ADDENDUM NO. 4

Re: Arch Job Number 24001, DCM #2025238, – Plans Dated: 3/31/25

New Lincoln Police Department

Lincoln, Alabama

SHEET
C6.1

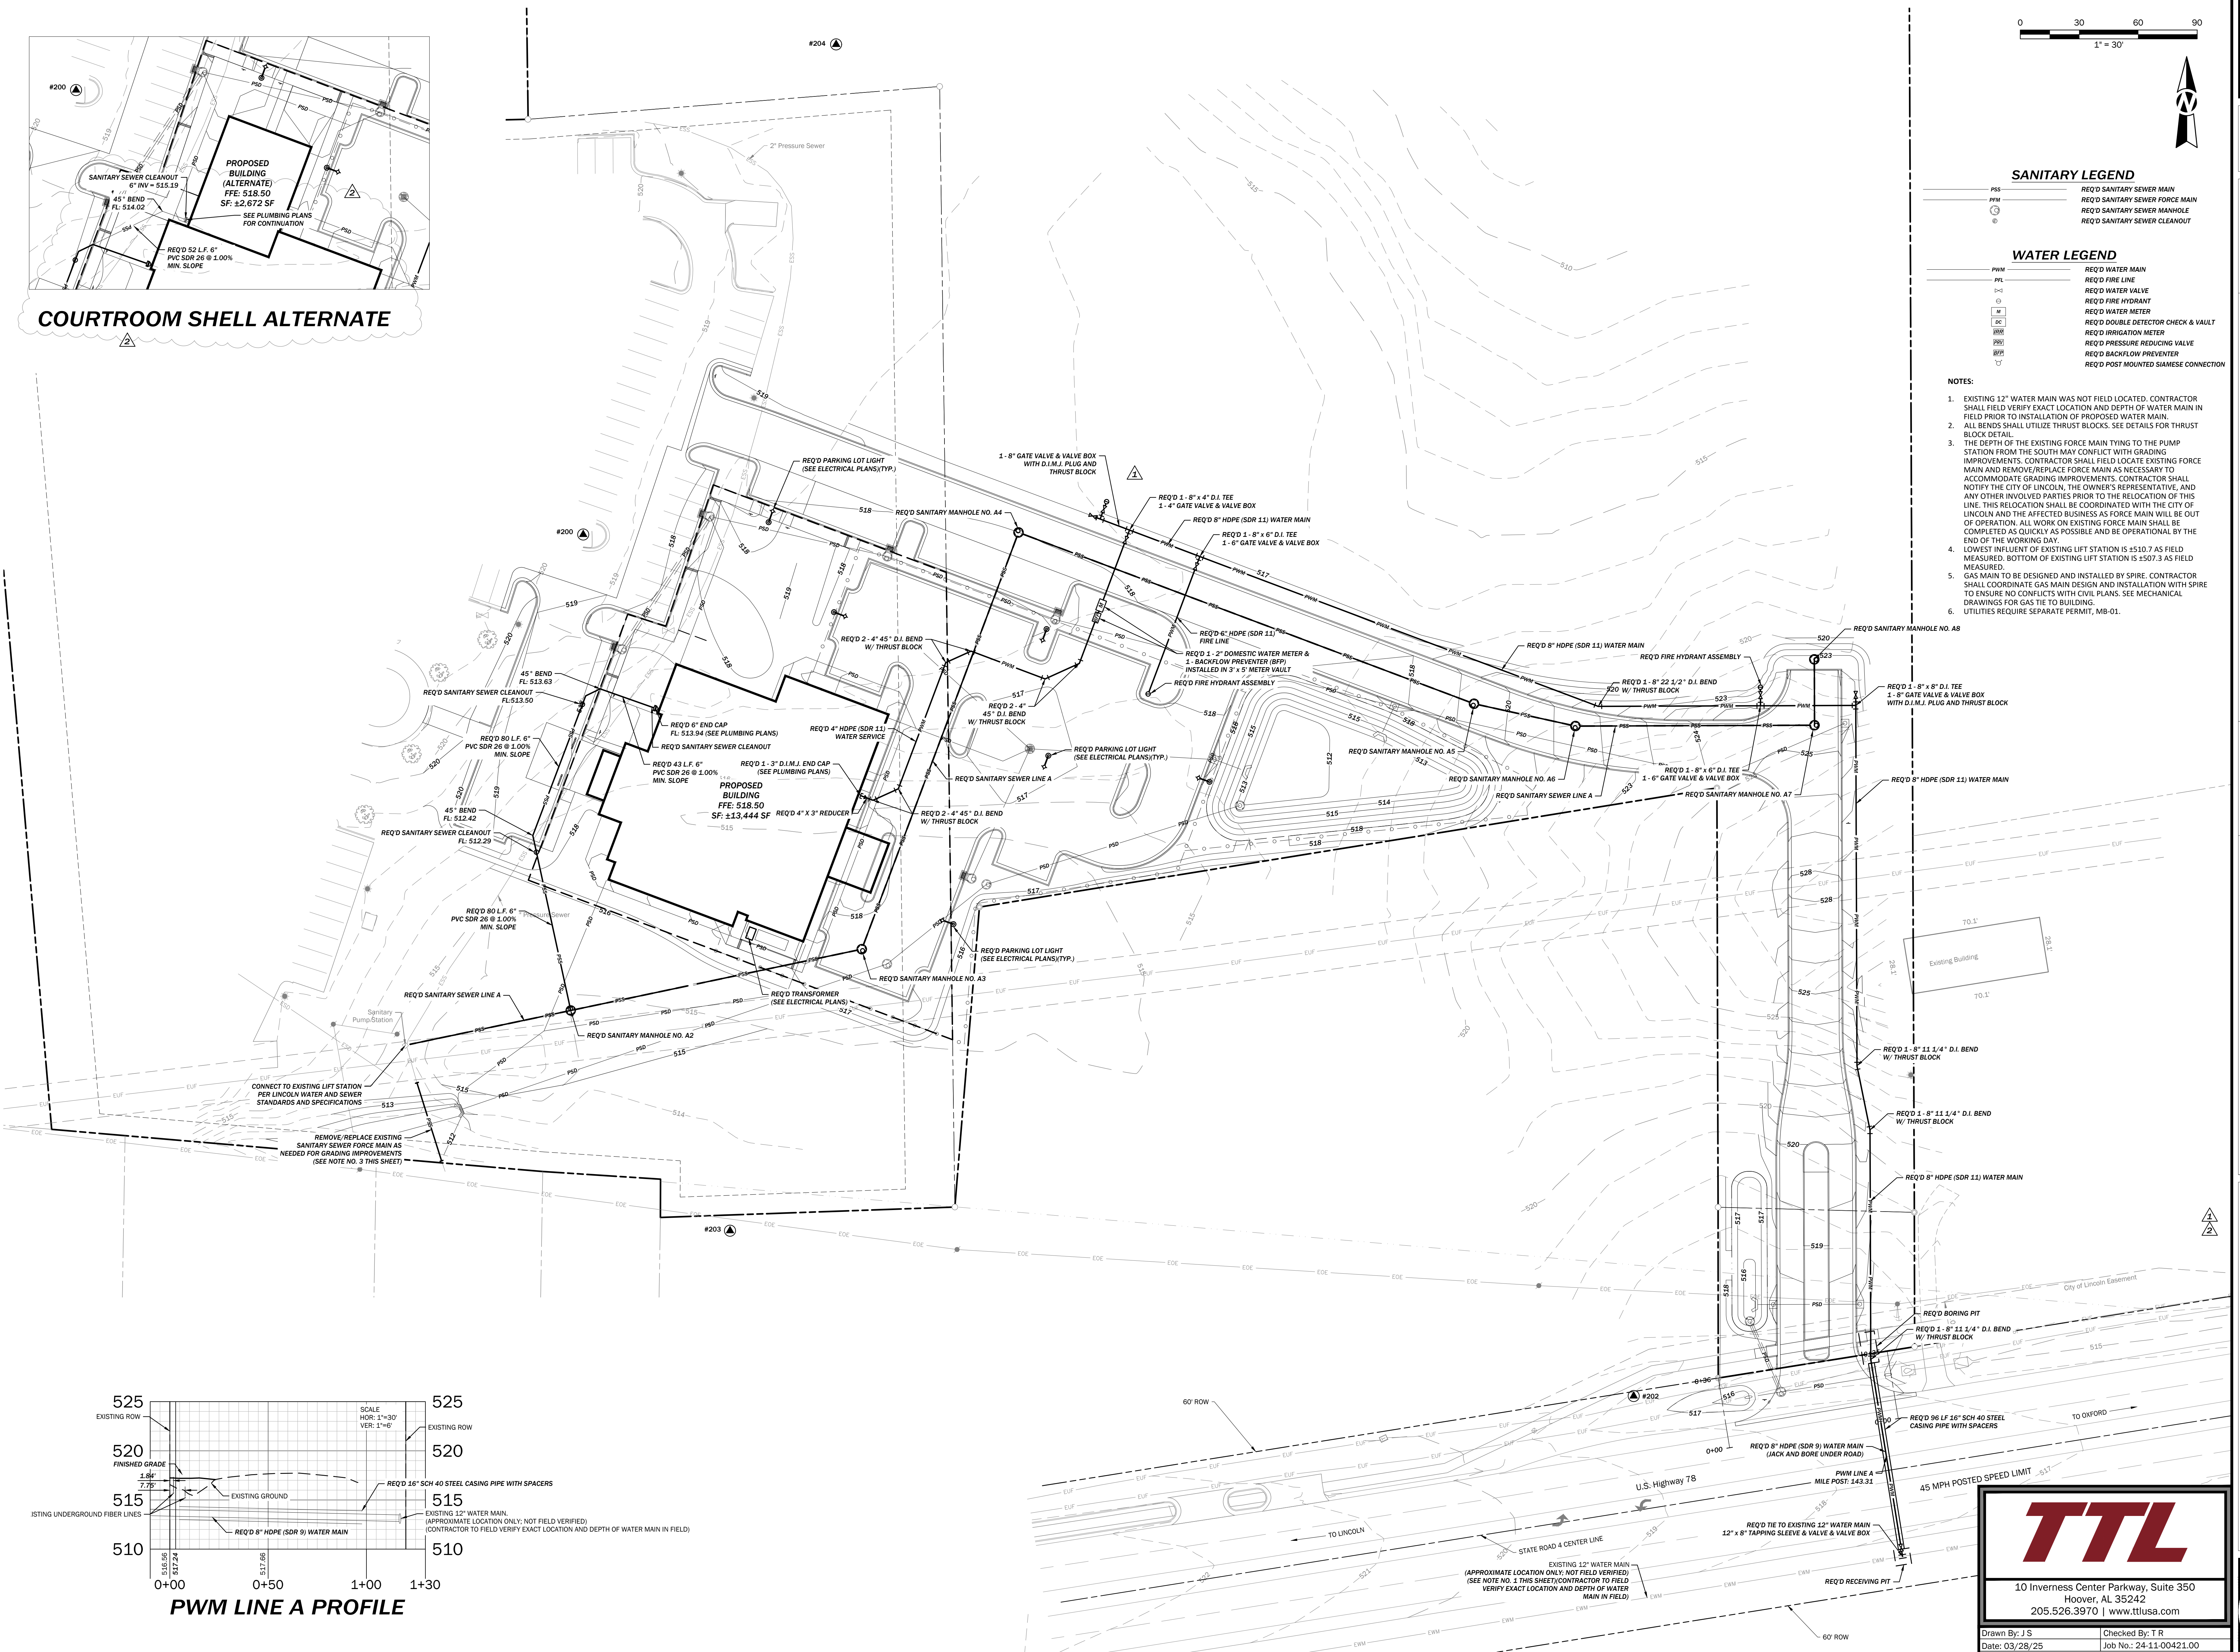
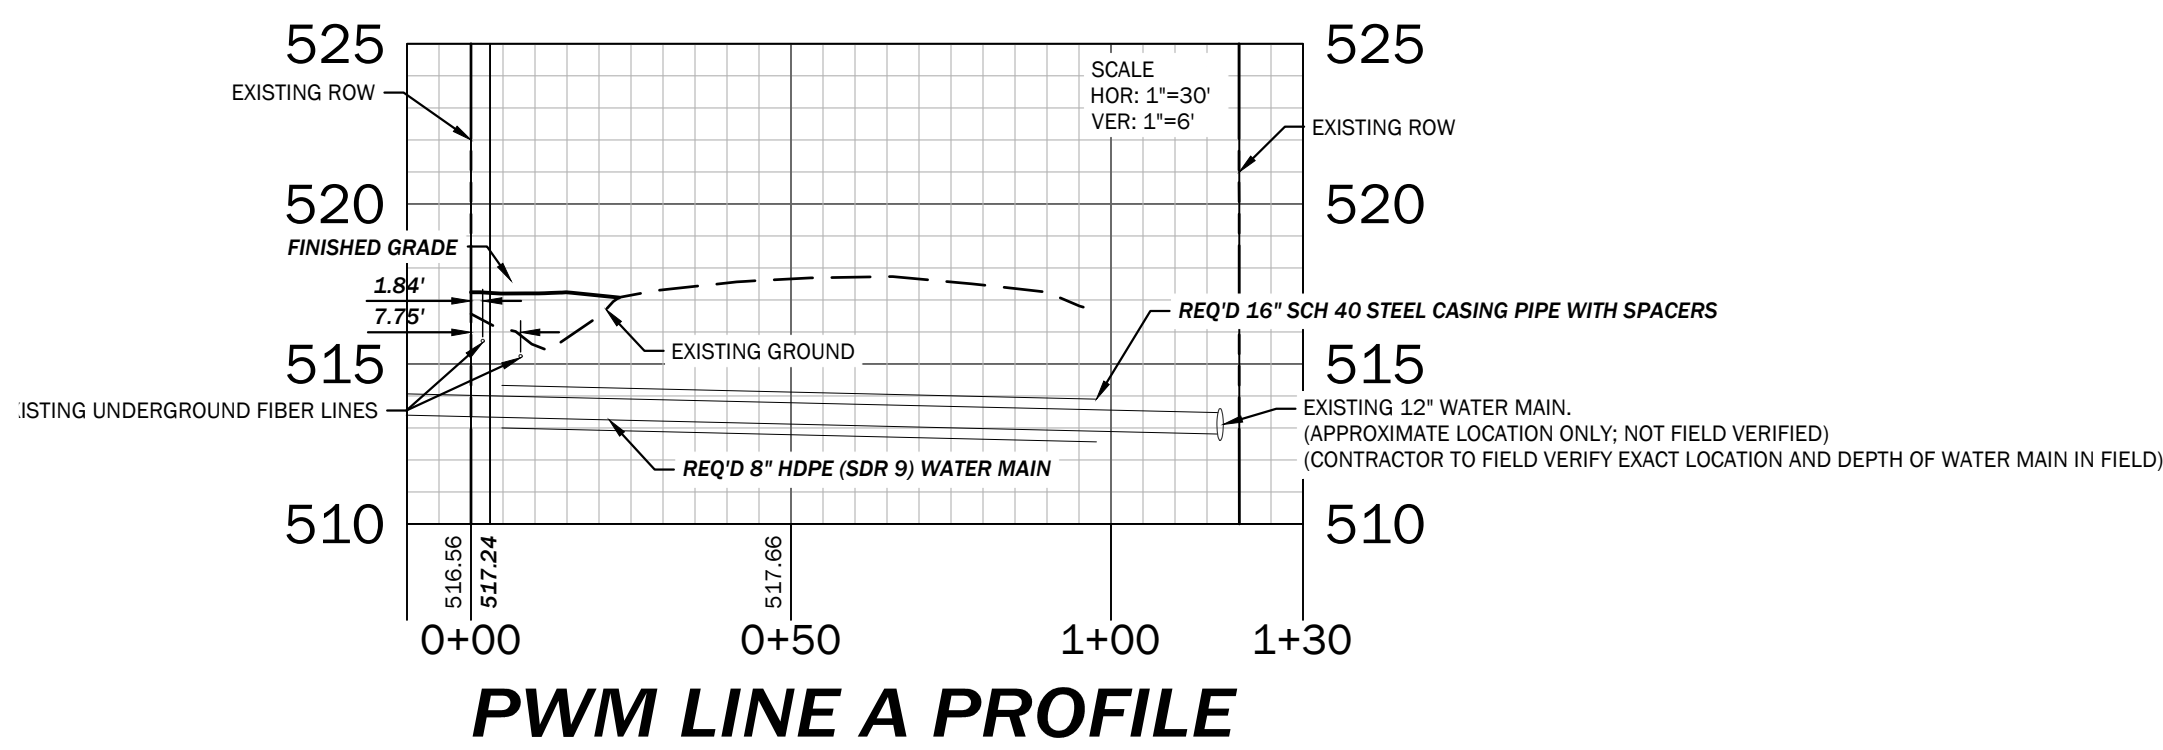
16. Question: Civil Utility C6.1 indicates 6" PVC SDR 26 sanitary piping, while all plumbing drawings indicate a 4" line coming into the building. Please clarify, as these drawings are not coordinated. Response: Drawings have been coordinated. Contractor to provide an expansion joint.
